Subject: Data Request No. 2 – San Diego Gas & Electric (“Applicant”), South Bay Substation Relocation Project (CPCN Application No. 10.06.007)

ATTACHMENT A

Data Request No. 2

Exhibit 1

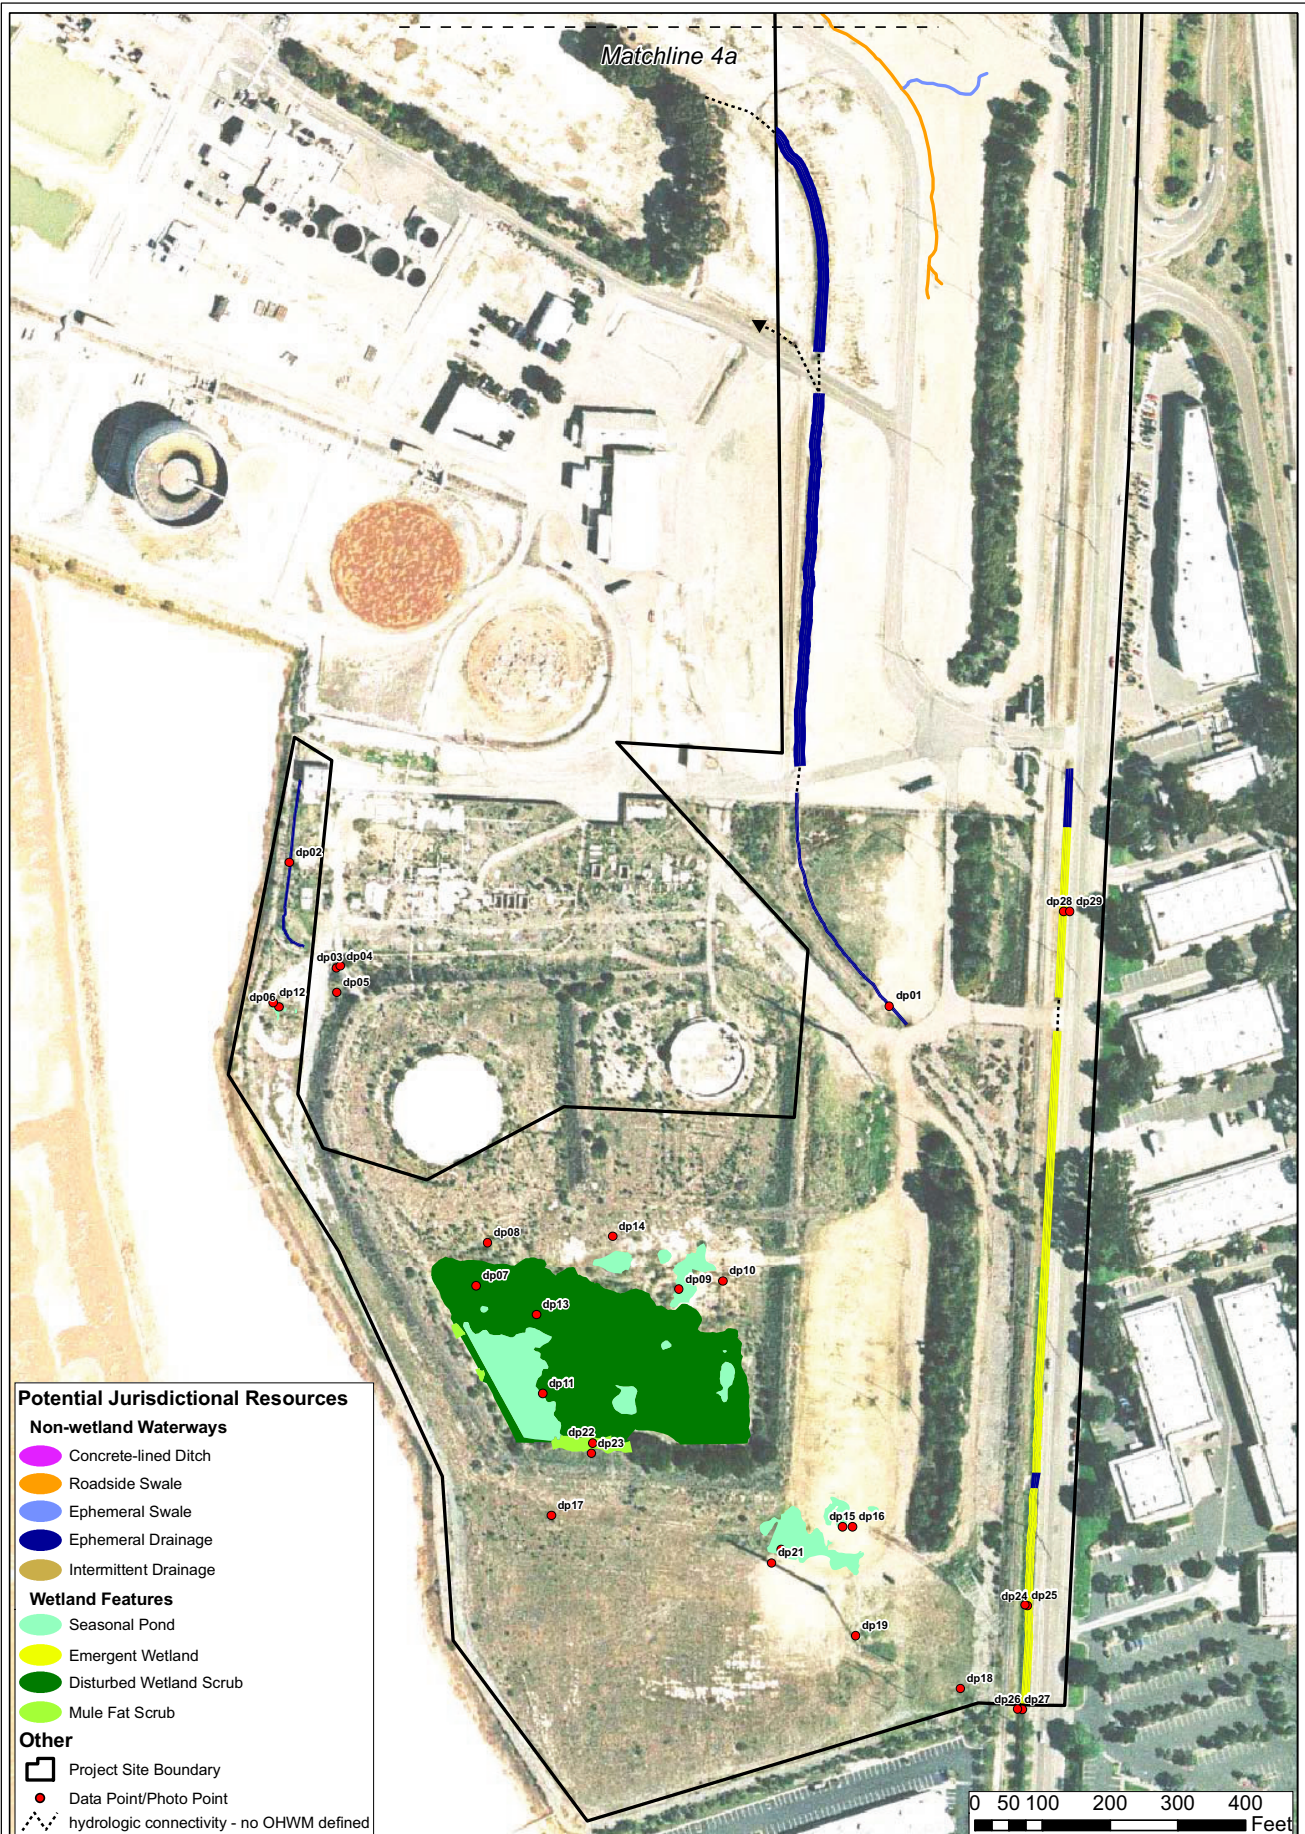
5. Wetland Data Request: Data Request 1 requested the geographic information system (GIS) files that were used to create exhibits included in the Preliminary Jurisdictional Wetland Delineation Report, dated June 11, 2010 (see *Exhibit 1*). The data received by SDG&E in response to this data request does not distinguish the different wetland features (i.e. seasonal pond, emergent wetland, mule fat scrub and disturbed wetland scrub). Please provide the GIS files that distinguish the different wetland features as depicted in *Exhibit 1*.
